TABLE OF CHANGES FOR PLANNING AMENDMENTS

Project Title
UNION, ST. JOHNS

Drawing Title
EAST ELEVATION

Drawing Number
6548-P-B500-E-E
Drawing Status
PLANNING

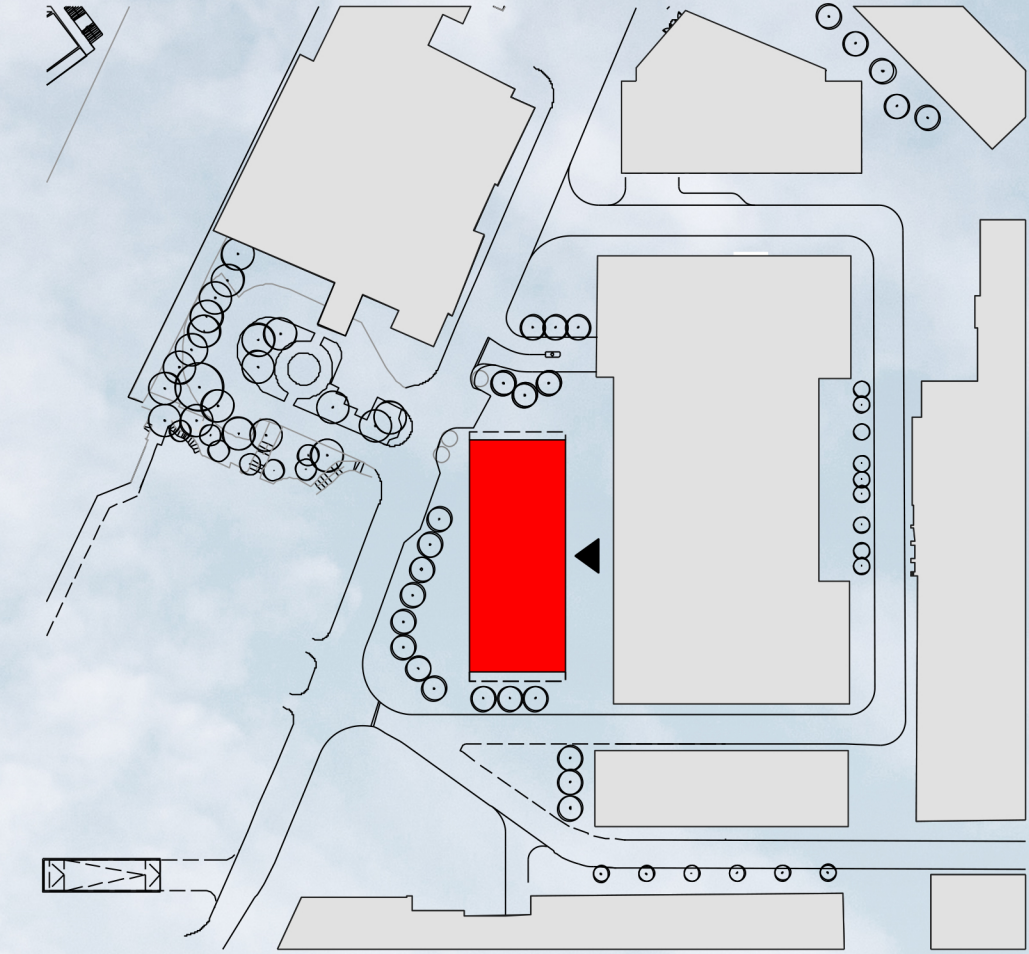
ITEM 2 - MATERIAL REFERENCE AMENDED
REFER TO TABLE OF CHANGES

ITEM 4 - EXTERNAL DOOR HEIGHT AMENDED
REFER TO TABLE OF CHANGES

ITEM 8 - POSTROOM HATCH OMITTED
REFER TO TABLE OF CHANGES

ITEM 4 - EXTERNAL DOOR HEIGHT AMENDED
REFER TO TABLE OF CHANGES

ITEM 5 - MATERIAL REFERENCE AMENDED
REFER TO TABLE OF CHANGES

ITEM 3 - MATERIAL REFERENCE AMENDED
REFER TO TABLE OF CHANGES

ITEM 9 - CURTAIN WALLING PANELS
RELOCATED
REFER TO TABLE OF CHANGES

ITEM 3 - LEVEL 01 SPANDREL PANEL MATERIAL AMENDED
REFER TO TABLE OF CHANGES

- 1 - EXTERNAL DOORS
SIZE/ FORMAT OF EXTERNAL DOORS AT GROUND FLOOR AMENDED
- 2 - FLOOR EDGE SPANDREL PANELS AMENDED
SPANDREL PANELS AT LEVEL 01 FLOOR EDGE CHANGED FROM BLACK BACK-PAINTED GLASS TO BLACK INSULATED OPAQUE ALUMINIUM

- 3 - LEVEL 01 SPANDREL PANEL MATERIAL AMENDED
SPANDREL PANELS TO WINDOWS AT LEVEL 01 CHANGED FROM BLACK BACK-PAINTED GLASS TO BLACK TINTED GLASS
- 4 - HEIGHT OF EXTERNAL DOORS AMENDED
HEIGHT OF EXTERNAL DOORS (TO EAST ELEVATION ONLY) REDUCED BY 200mm

- 5 - LEVEL 01 SPANDREL PANEL MATERIAL AMENDED
SPANDREL PANELS TO WINDOWS INTO AMENITY WC AREA (TO EAST ELEVATION ONLY) CHANGED FROM BLACK BACK-PAINTED GLASS TO INSULATED OPAQUE ALUMINIUM

- 8 - POST ROOM HATCH OMITTED
OPENING HATCH/WINDOW TO POSTROOM ON GROUND FLOOR EAST ELEVATION OMITTED
- 9 - CURTAIN WALLING PANELS RELOCATED
CURTAIN WALLING PANELS RELOCATED ON LEVEL 01 IN CONNECTION WITH INTERNAL REORGANISATION OF LEVEL 01 AMENITY SPACE
